Access Compliance Report

Public Rights-of-Way

Main Street: ADAMS_ST Cross Street: BOLSA_AVE Location: NE

ADA ID: RPRK211004173551 Ramp Type: Type 1 - Perpendicular Diagonal Initial Pass/Fail: Fail Overall Compliance: No Severity Score: 34

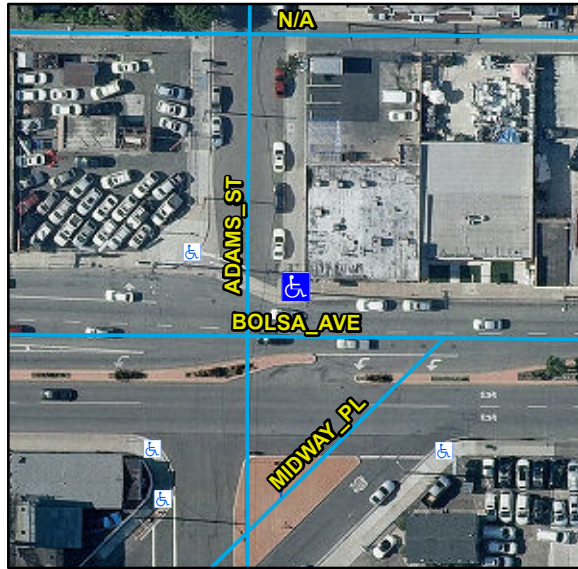
Compliance	Description	Data	Compliance	Description	Data
N/A	Ramp Length (in)	96	N/A	Flare Type LT	
No	Ramp Width (in)	36			N/A
No	Ramp Run Slope (%)	12.9	N/A	Flare Slope LT (%)	N/A
Yes	Ramp Cross Slope (%)	0.9	N/A	Flare Traversable LT	N/A
N/A	Landing Present	N/A	N/A	Flare Type RT	
N/A	Landing Length (in)	N/A			N/A
N/A	Landing Width (in)	N/A	N/A	Flare Slope RT (%)	N/A
N/A	Landing Run Slope (%)	N/A	N/A	Flare Traversable RT	N/A
N/A	Landing Cross Slope (%)	N/A	N/A	DWS Provided	N/A
N/A	Landing Movement Obstructed?	N/A	N/A	DWS Contrast	N/A
	Landing Movement Type	N/A	N/A	DWS Length (in)	N/A
N/A	Landing Shared	N/A	N/A	DWS Full Width	N/A
N/A	Clear Space	Yes	N/A	DWS Offset Left (in)	N/A
N/A	Clear Space To Crosswalk (in)	N/A	N/A	DWS Offset Right (in)	N/A
N/A	Marked Crosswalk 1	No	N/A	Marked Crosswalk 2	No
	Crossing 1 Direction	NW		Crossing 2 Direction	S
	Marked Crosswalk 1 Width (in)	N/A		Marked Crosswalk 2 Width (in)	N/A

N/A	Ramp Inside Crosswalk 1	N/A	Yes	Ramp Inside Crosswalk 2	N/A
	Crossing 1 Slope (%)	5.8		Crossing 2 Slope (%)	7.2
	Crossing 1 Cross Slope (%)	3.1		Crossing 2 Cross Slope (%)	1.6
N/A	Gutter Ponding	N/A	No	Curb Slope	13.5
Yes	Gutter Lip Height (in)	0		Road Run Slope (%)	3.1
N/A	Gutter Run Slope (%)	N/A		Road Cross Slope (%)	3.7
N/A	Gutter Cross Slope (%)	N/A			
Yes	Overall Surface Condition: Acceptable		Yes	Perp Joint Present	Yes
	Cross Gutter Present?	No		Spandrel Present?	Yes
	Replace Cross Gutter?	N/A		Replace Spandrel?	No

Remove & Replace Curb Ramp With Two New Directional Ramps or Equivalent.
